Re: ***375 Main Street – Site Plan Approval  
Section 108.03, Block 1, Lot 75***

As you know, we represent NY Fuel Distributors, LLC (the “Applicant”) in connection with the above-referenced property (the “Subject Property”). We respectfully submit herewith the following amended plans for your consideration at your upcoming meeting on February 22, 2021.

The proposed plans have been revised in accordance with comments raised during the Planning Commission meeting on February 8, 2021. Due to the quick turnaround time this submission is not intended to respond to all of the latest comments from the Town Planner and Engineer, rather this submission is intended to address the comments of the Board so the Board can consider a recommendation to the Zoning Board of Appeals.

DRAWING TITLE:  
**PROPOSED LANDSCAPING PLAN**

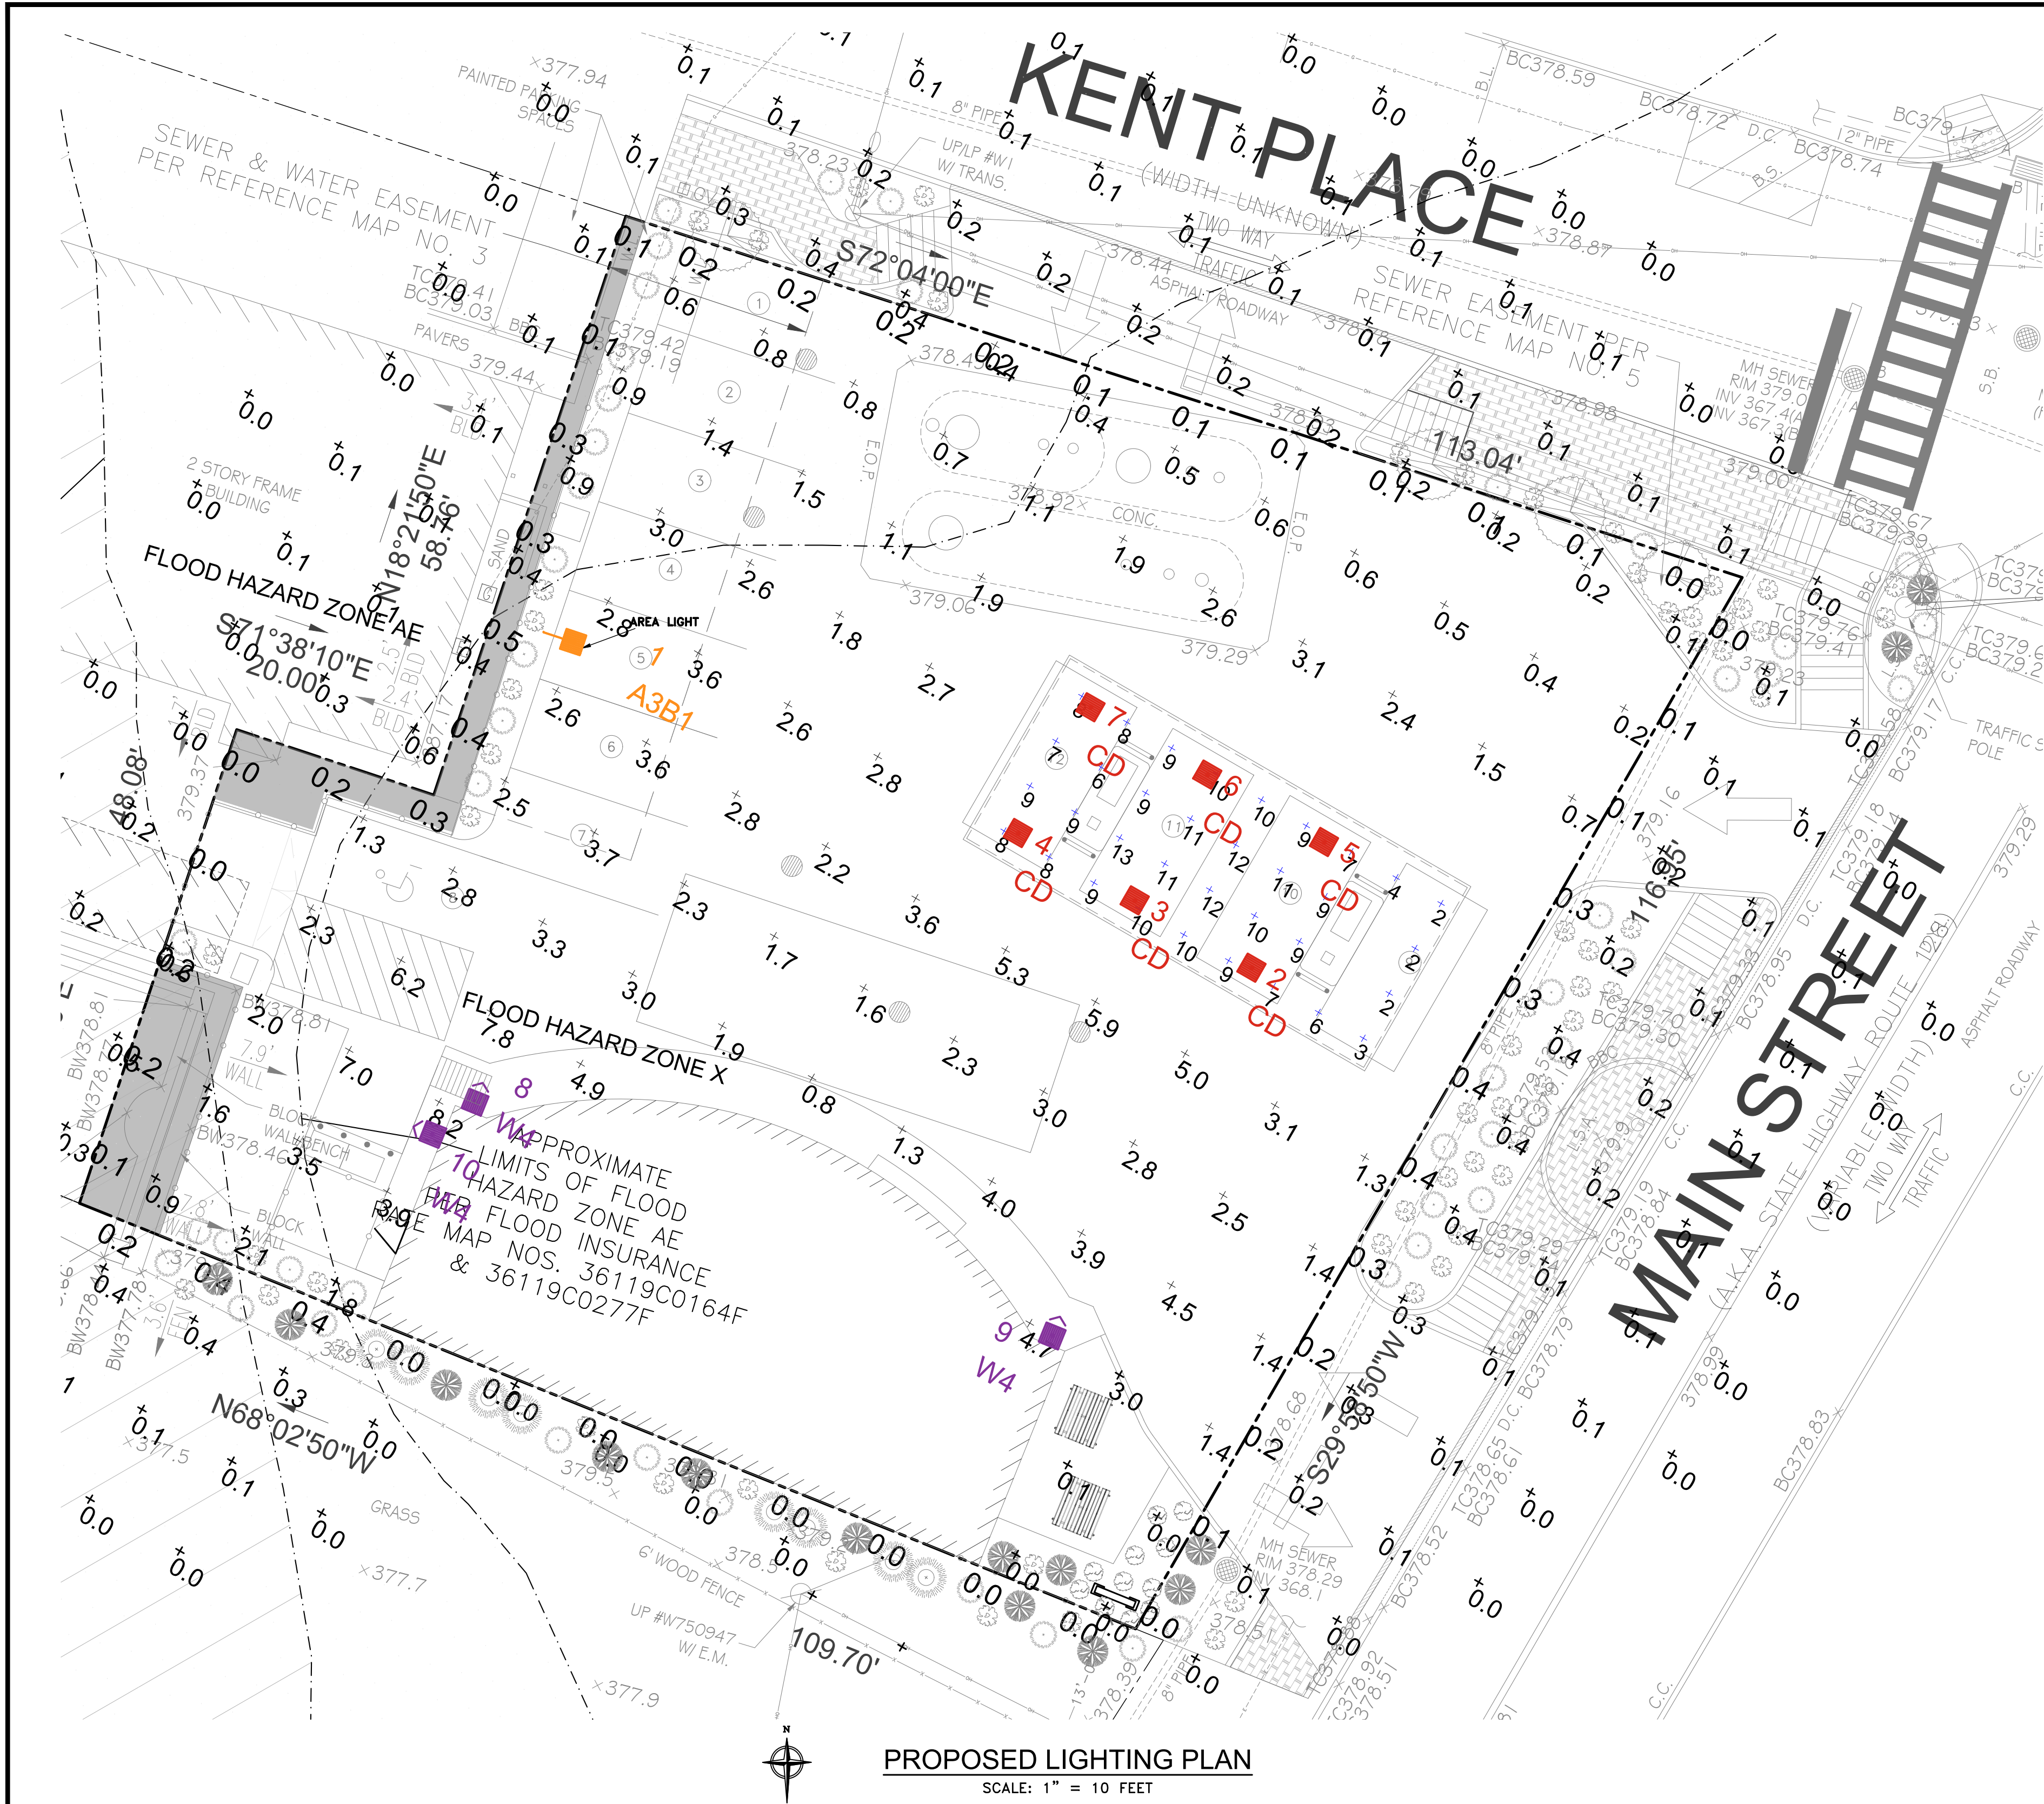
Lastly, the proposed landscape plan has been revised to incorporate a mix of Italian Cypress trees along the rear façade at the corners and in between the windows. The Applicant has also expanded the landscaping to include portions of the area previously proposed for the employee parking spaces which also reduces the amount of proposed impervious surfaces within the wetland buffer.
